ORDINANCE NO. 24-3-5

An ordinance approving and authorizing the execution of Change Order No. One (1) for the Barber Road Bank Stabilization, (Project No. P210702), to increase the contract amount by \$64,659.69 and increase the contract time by 7 calendar days.

CHANGE ORDER

Project: Barber Road Bank Stabilization

DRAINAGE PLAN/PROFILE
PAPER ROAD BANK STABILIZATION

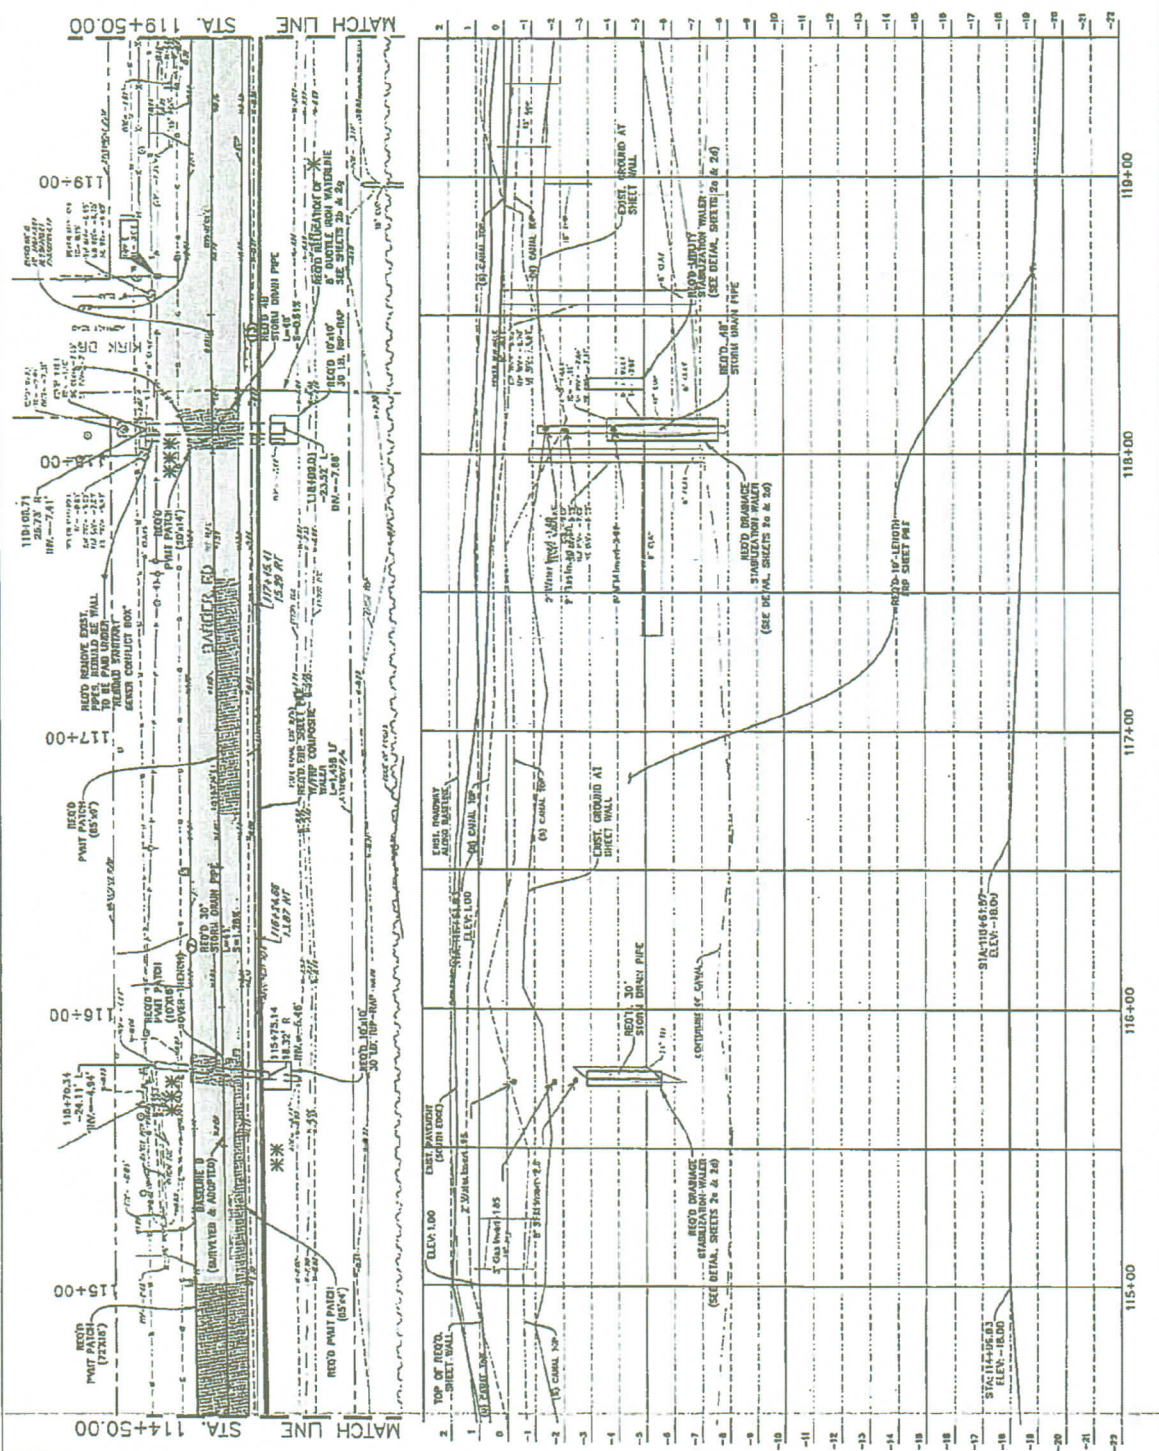
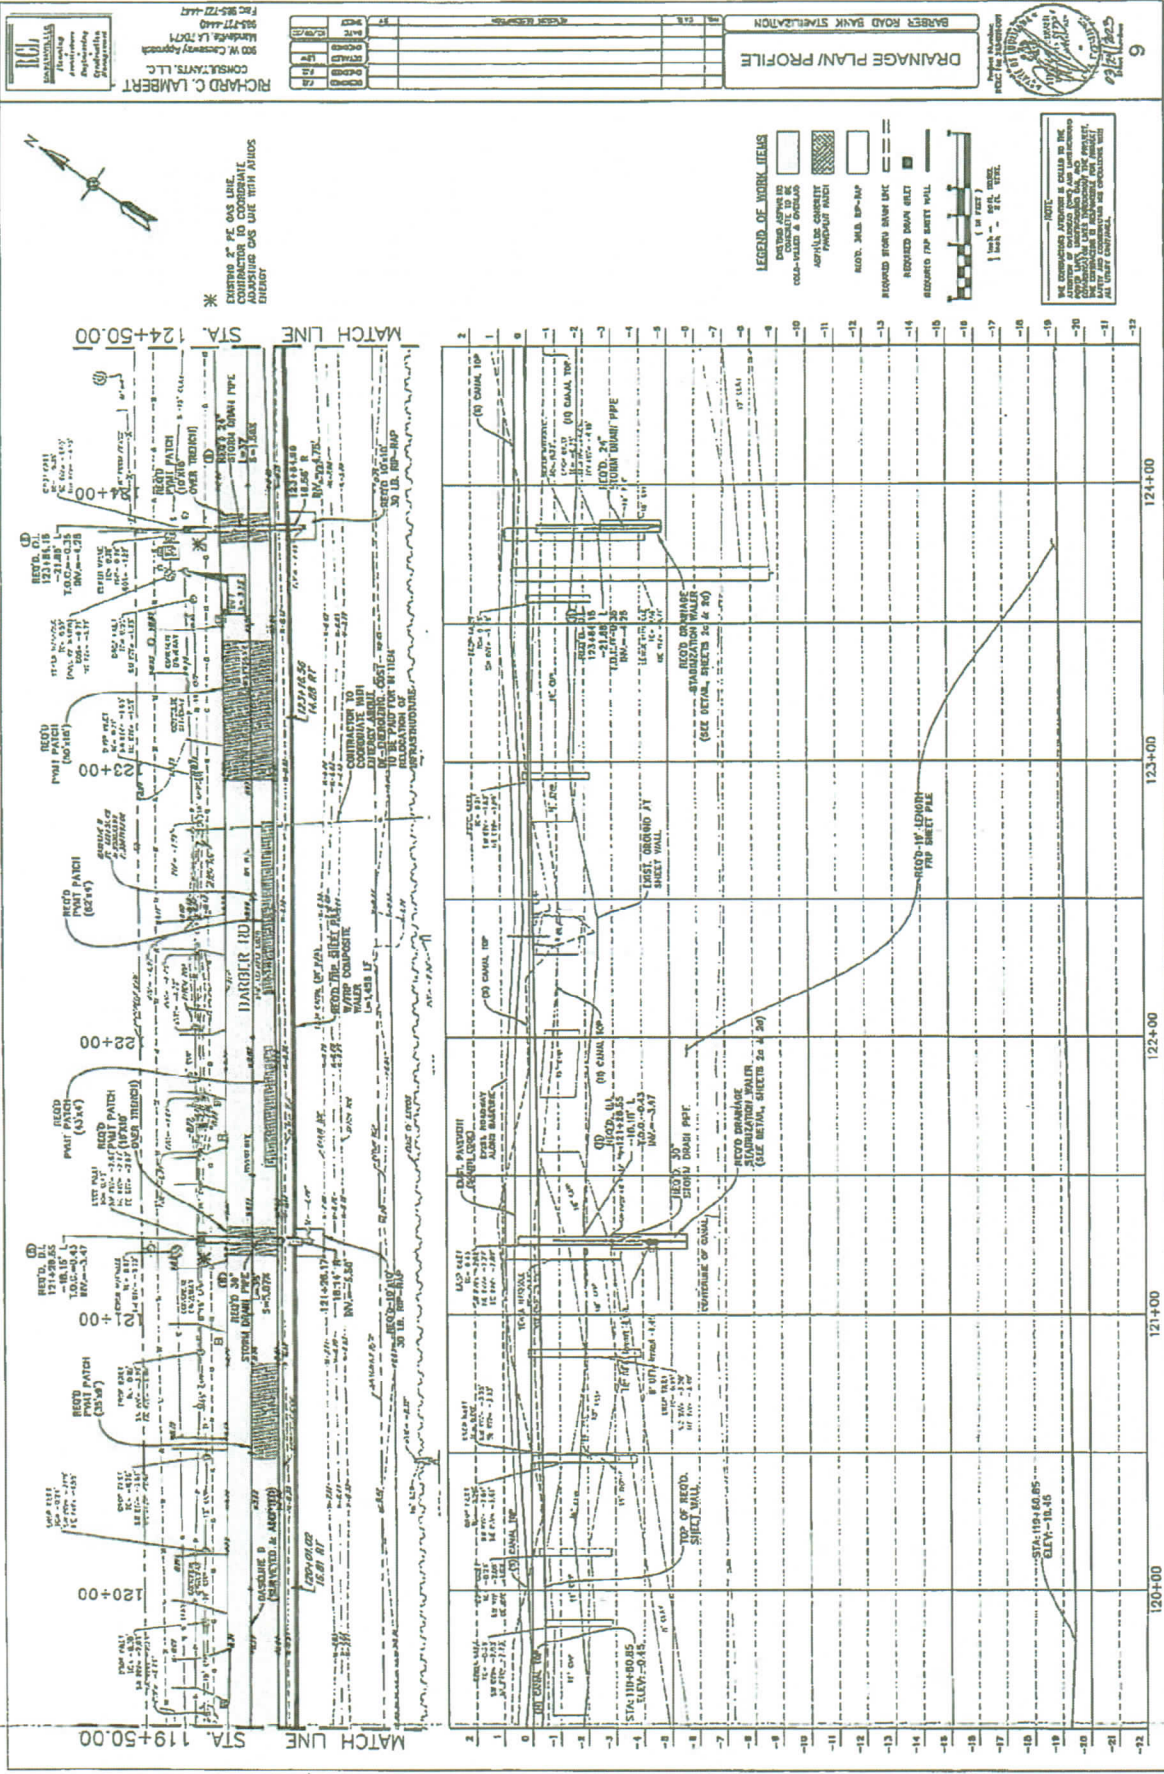
Description: Enter description of changes for Contractor.
In reference to RFI 05, at Sta. 118+08, Command has been authorized to perform a SFM offset on the known SFM conflict and a second offset on the second SFM beneath the roadway, if confirmed to be in conflict. Please confirm second offset with SCP and RCLC as soon as exposed. SFM offsets to be paid under item TS-741-10009 - 8" WATER LINE OFFSET item for 6", 8", or 12" SFM offsets.

State Project No.: P210702		RFI Number: 5	
Project Name: Barber Road Bank Stabilization		Date Received: 10/11/2023	
Project Manager: Arthur Ledet		Date Required: 10/12/2023	
Project Engineer: Frank Zemmer		Forwarded To:	
Contractor: Command Construction, LLC		Date Responded: 10/11/2023	
Specification No.:		Page No.:	
check one: <input checked="" type="checkbox"/> RFI	<input type="checkbox"/> Design Modification	<input type="checkbox"/> Proposed VE	
check one: <input type="checkbox"/> Standard Specification	<input type="checkbox"/> Supplemental Specification	<input type="checkbox"/> Special Provision	
Plan Sheet No.: 7 thru 9		Detail:	
REQUEST:			
While performing exploratory excavation, Command found numerous conflicts with our new drain line, including the gas and SFM's. Please see the attached redline drawings showing the conflicts from our findings highlighted in yellow.			
PROPOSED SOLUTION (If applicable):

Engineer to advise Command on a proposed solution.			
By: Bradley Cieslinski		Signature: <i>Bradley Cieslinski</i>	Date: 10/11/2023
RESPONSE:			
Please provide horizontal locations on plan view for SFM. Station 113+03.37 drainage has been relocated through RFI#2 and should no longer be in conflict. It appears from the redlines on the drawings that the gas lines are above the drainage and not in conflict. Once RCLC has the horizontal SFM information, we can respond in detail to the remaining conflicts mentioned in this RFI.			
By: Angela Eymard, PE		Signature: <i>Angela Eymard</i>	Date: 10/11/2023
After reviewing the response, does the contractor anticipate:			
That a change order will be required? <input type="checkbox"/> Yes		<input checked="" type="checkbox"/> No	
That there will be an increase in the cost of the project? <input type="checkbox"/> Yes		<input checked="" type="checkbox"/> NO

DATE: 11/11/2008
PROJECT: HABLER ROAD BANK STABILIZATION
SHEET NO.: 6

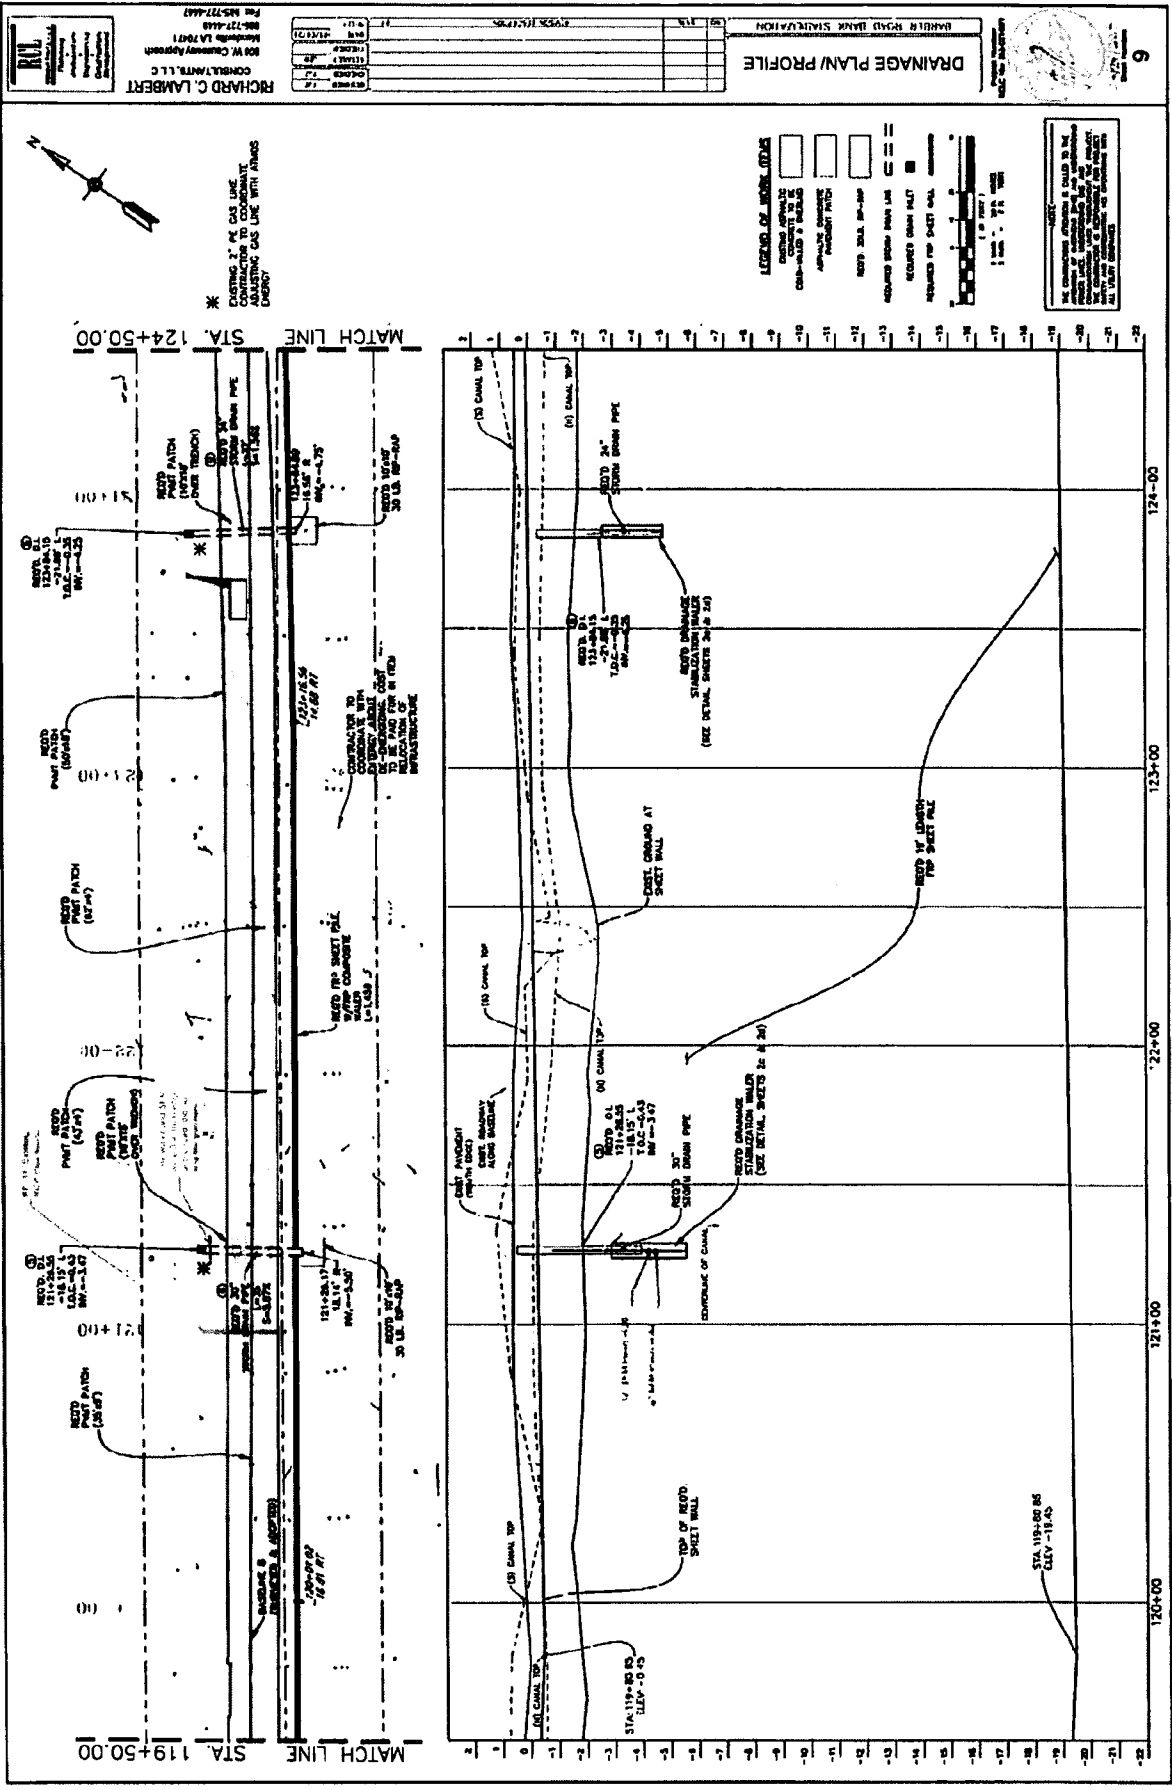
In reference to RFI 11, replace existing 15" CMP with 18" Storm Drain Pipe CPPPDW Adjust top of existing box to driveway elevation with closed top cover. D.I adjustment to be paid under Item 702-04-00200 ADJUSTING DRAIN INLETS. 6' x 18' PAVEMENT PATCHING, 10' x 10' RIP RAP and DRAINAGE STABILIZATION WALER to be paid under existing contract items. Command to submit pricing for R/R concrete Driveway.

DRAINAGE PLAN/PROFILE

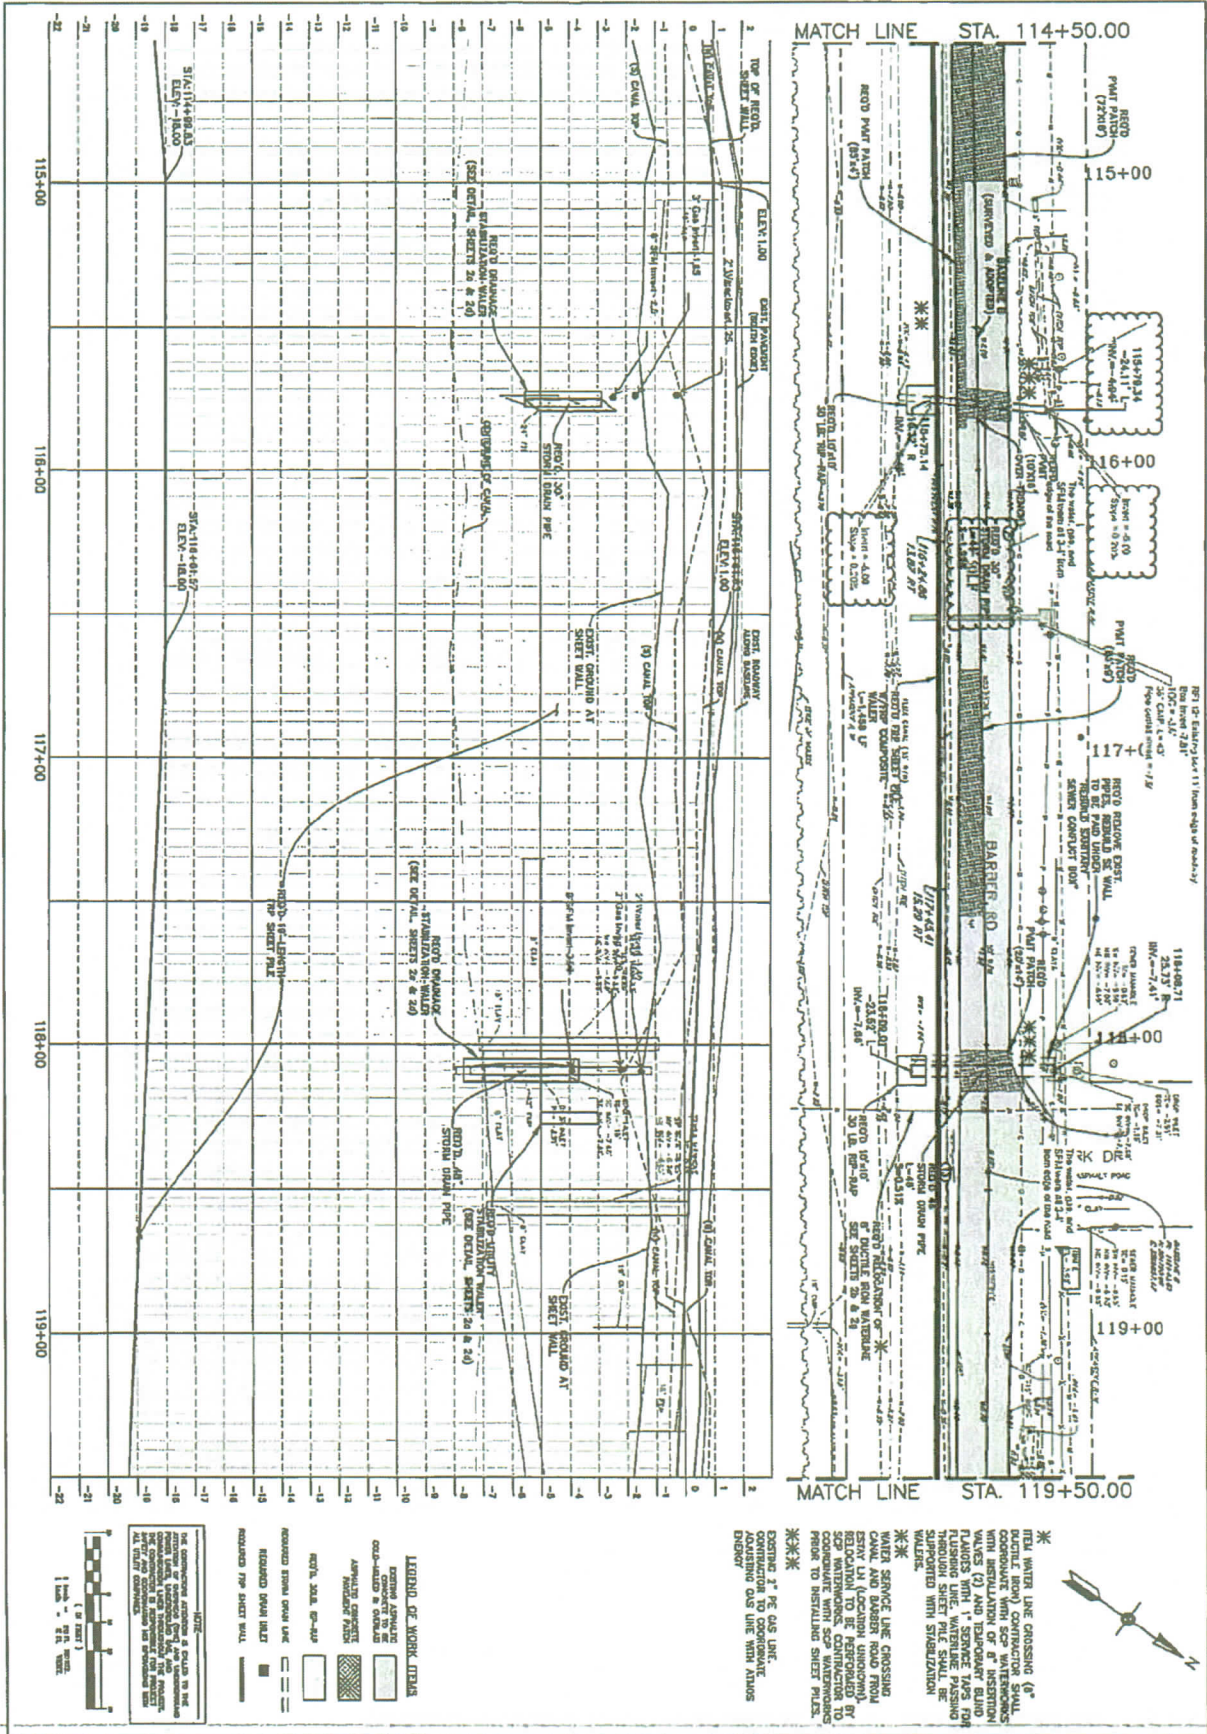
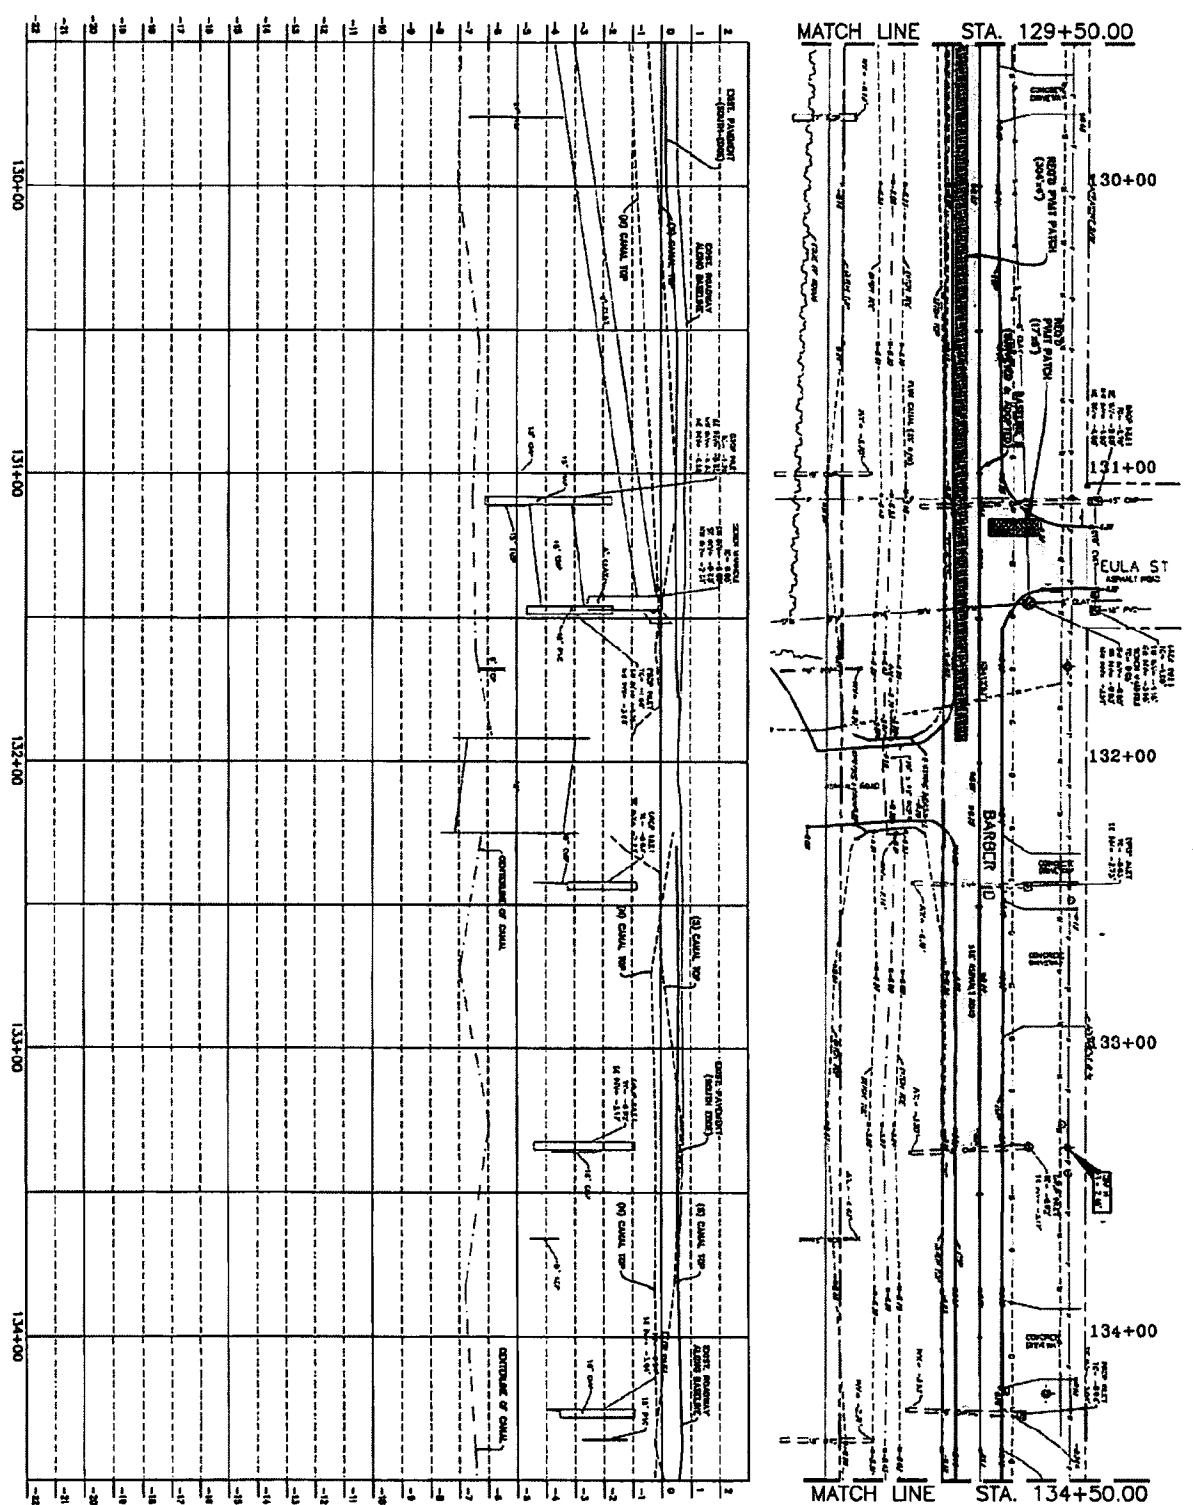
Description: Enter description of changes for Contractor.
The cross drain at Sta. 132+42 was added to the project per SCP DPW during the pre-construction walk through due to the culvert being washed out. Additionally, at Sta. 115+79 the pipe was extended an additional 10 LF due to the pipe invert being adjusted to avoid conflicting utilities.
701-03-01022 - 18" STORM DRAIN PIPE (CPPPDW) - 50 LF (40 LF for Sta. 132+42 & 10 LF for Sta. 115+79)
711-01-00300 - RIP RAP (30 LB, 14" THICK) - 11.11 SY
Attachments: (List documents supporting change) List of supporting documents.
Pages 3-4 - Mark-up plan sheets 8 & 11
